HISTORIC AND DESIGN REVIEW COMMISSION

May 20, 2020

HDRC CASE NO: 2020-137
ADDRESS: 3303 BROADWAY
LEGAL DESCRIPTION: NCB 6298 BLK 4 LOT 194
ZONING: C-3, RIO-1
CITY COUNCIL DIST.: 2
APPLICANT: Zachary Villejo/Villejo Enterprises D.B.A. Good Guys Auto Group
OWNER: Zachary Villejo/Villejo Enterprises D.B.A. Good Guys Auto Auto
TYPE OF WORK: Installation of a prefabricated structure
APPLICATION RECEIVED: March 10, 2020
60-DAY REVIEW: Not applicable due to City Council Emergency Orders
CASE MANAGER: Edward Hall

The applicant is requesting a Certificate of Appropriateness for approval to place a prefabricated structure on the lot located at 3303 Broadway. The proposed structure will feature approximately 1, 300 square feet in size.

REVISION	BY	DATE	DRAWN BY	PROJECT	TITLE	DWG. NO.	SHEET	DATE	SCALE	PROJECT	PHONE
			R.C.	WILLIAMS SCOTSMAN	FLOOR PLAN	WS2454-11	A-2	5/18/2006	3/16" = 1'-0"

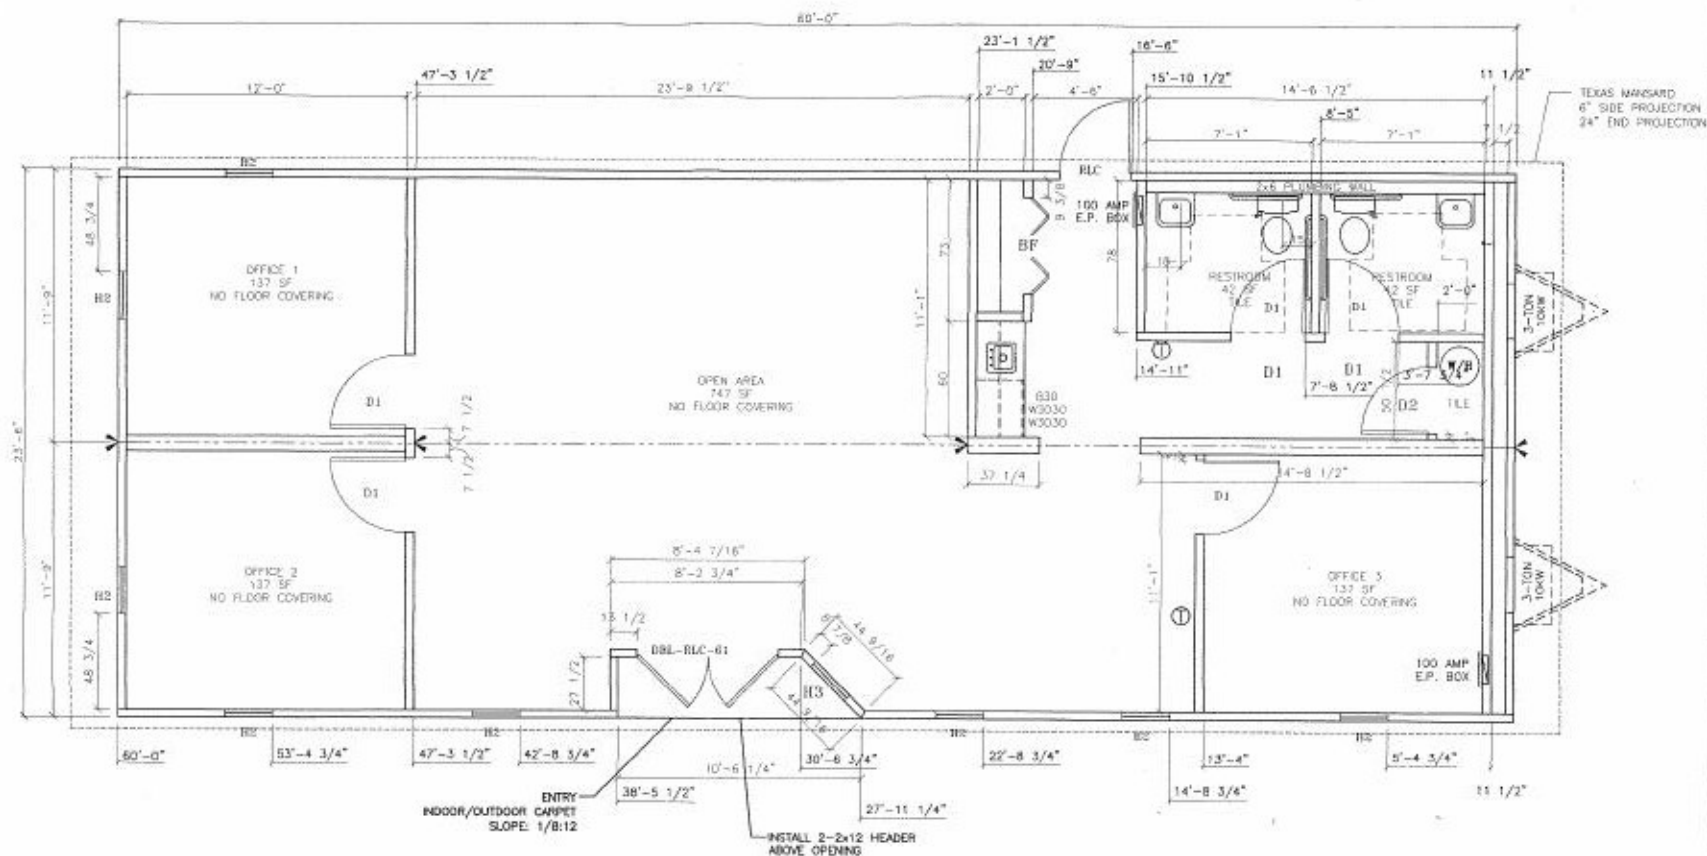
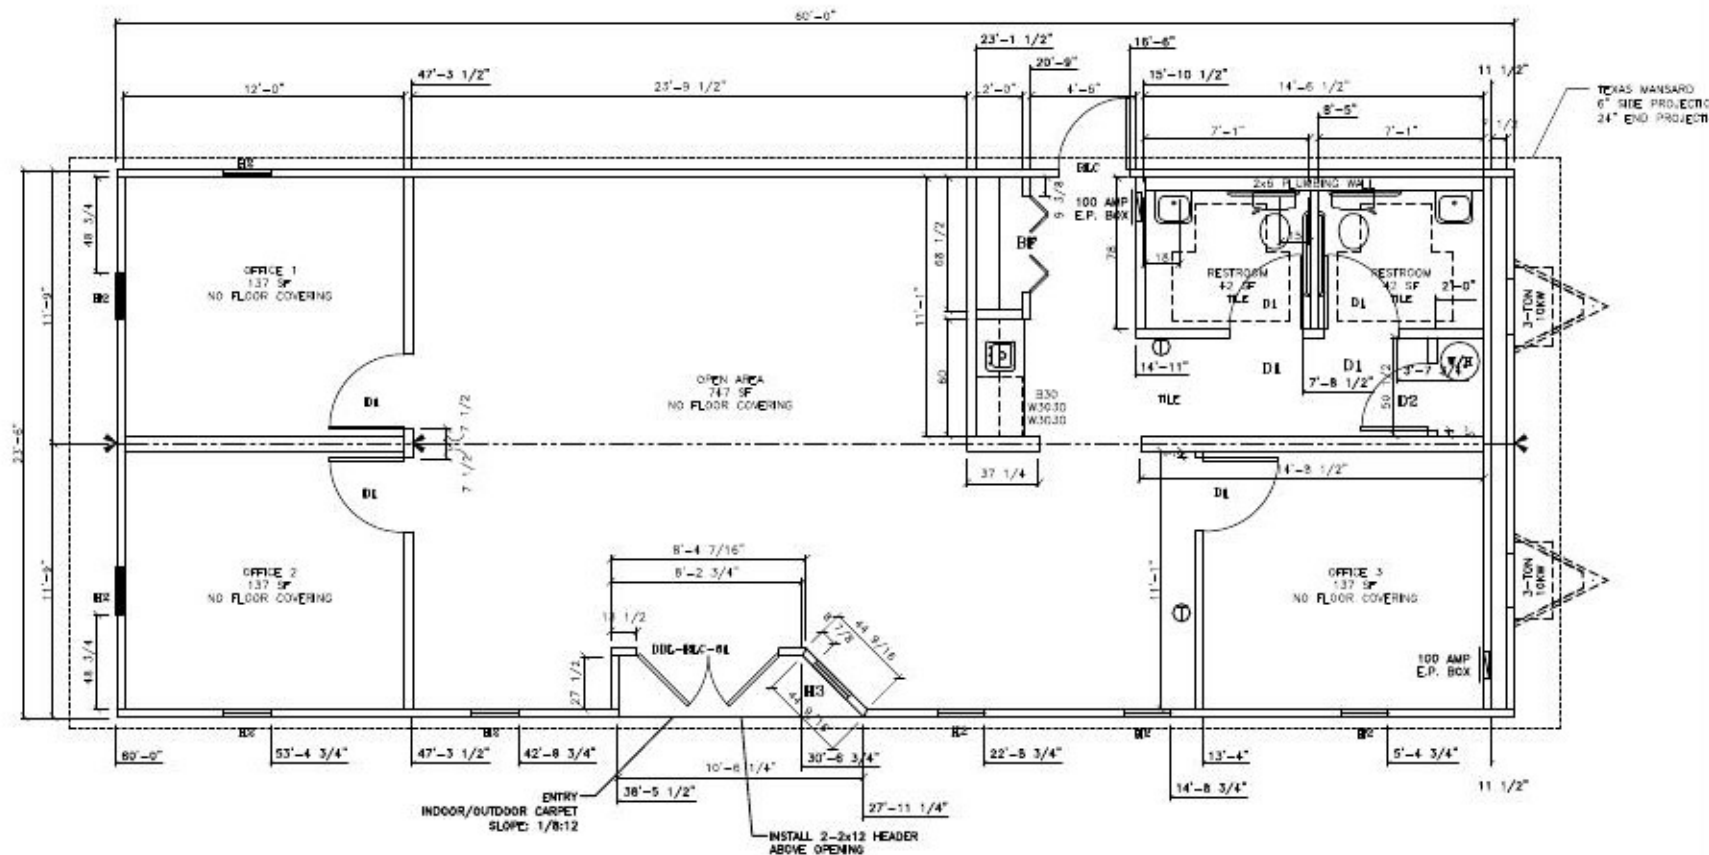
- f. FAÇADE ARRANGEMENT – Per the floor plan, the proposed structure will feature large expanses of wall with no separation or fenestration. This is not consistent with the UDC Section 35-674(e)(2).

- h. WINDOWS – According to the UDC Section 35-674(e)(2), windows help provide human scale and should be recessed at least two (2) inches within solid walls; windows should relate in design and scale to the spaces behind

Staff does not recommend approval at this time. Staff recommends that the applicant submit complete construction documents of the proposed structure, including elevation drawings. Additionally, staff finds that windows should be metal and inset at least two (2) inches within walls, that materials follow the UDC's standards, and that all mechanical equipment be screened from view from the public right of way.
